Code Technologies Committee Report Fire Rated Glazing – Group A changes:

Fire rated glazing

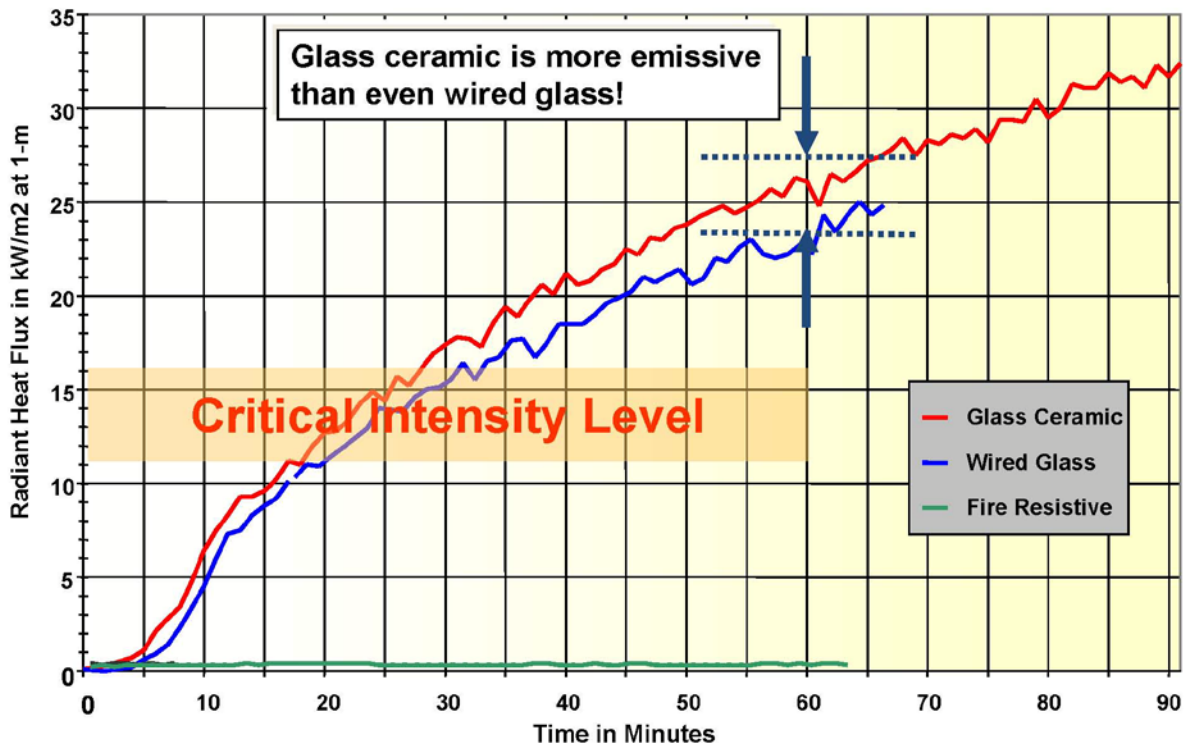
If the limited amount of glazing in a fire door presents a risk, fire windows along a corridor or exit passageway would be a greater risk. Within NFPA 80 Appendix I the opening paragraph states:

I.1 Background. Fire windows were originally designed for protecting openings in exterior walls. In such applications, radiant heat transfer was not a significant consideration, since the main function of fire windows was to contain the flames within the building. However, where fire windows are used in interior partitions, users of this standard might need to consider radiant heat transfer during fire. Exiting through corridors and past fire windows could be compromised, and combustible materials on the unexposed side of fire windows could be ignited. The information that follows is a guide to the evaluation of radiant heat transfer through fire windows.

The third paragraph of NFPA 80 Appendix I states:

Test Method. Because the present fire test standard, NFPA 257, does not require measuring and reporting temperature rise on the unexposed face of the glazing material or radiant heat transmission, glazing products tested to this standard have not been required to retard heat transfer. However, these data are required in many European fire test standards. [2] As a result, European building codes place limitations on the use of glazing in fire-resistant partitions inside buildings and require the use of insulating glazing in means of egress as well as where combustibles could be in close proximity
